Technical Memorandum

Subject: Interim As-Built Survey for the Strawberry Creek Restoration Project at Redwood National Park in Orick, CA (CDFW FRGP #P1110508)

Attachment 1: Interim As-Built Plans (11,7/14)

STRAWBERRY CREEK RESTORATION PROJECT

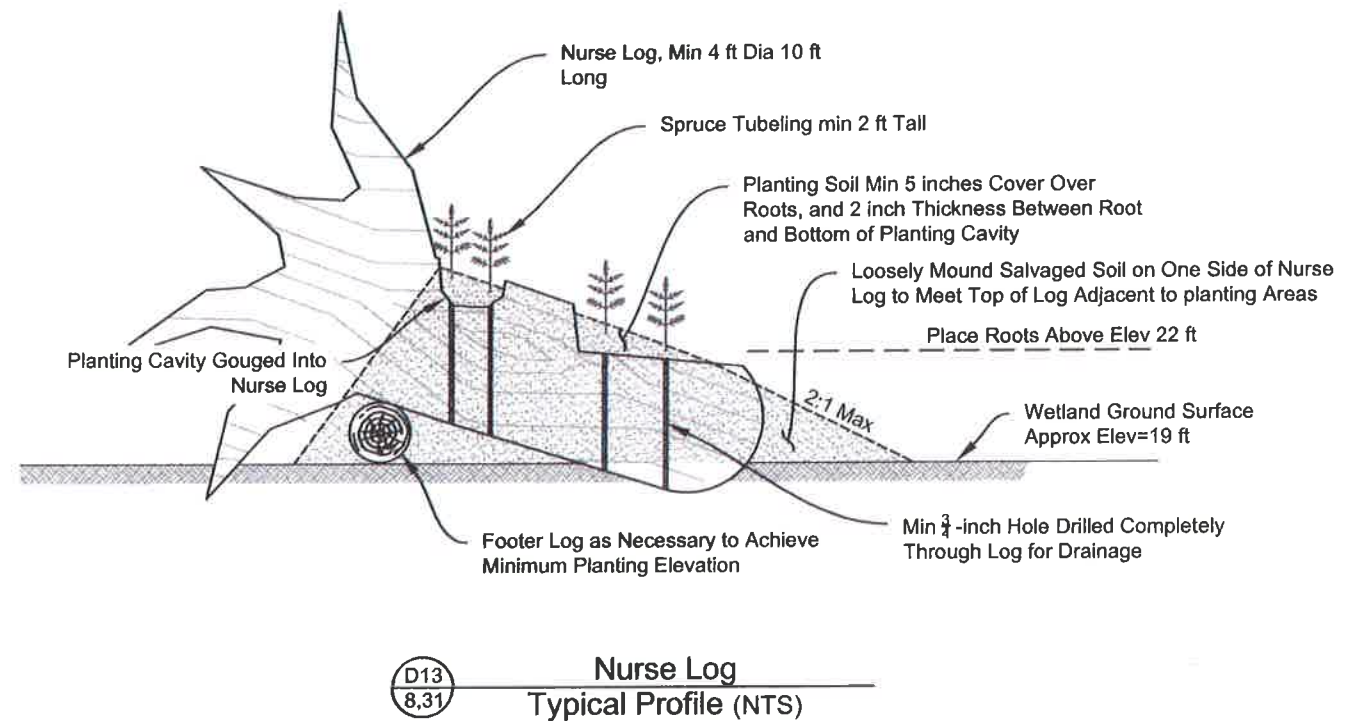
NOT CONSTRUCTED
NOV 7, 2014

NOT CONSTRUCTED
NOV 7, 2014

NURSE LOGS PLACED AS SHOWN, NOT PLANTED
AS OF NOV 7, 2014
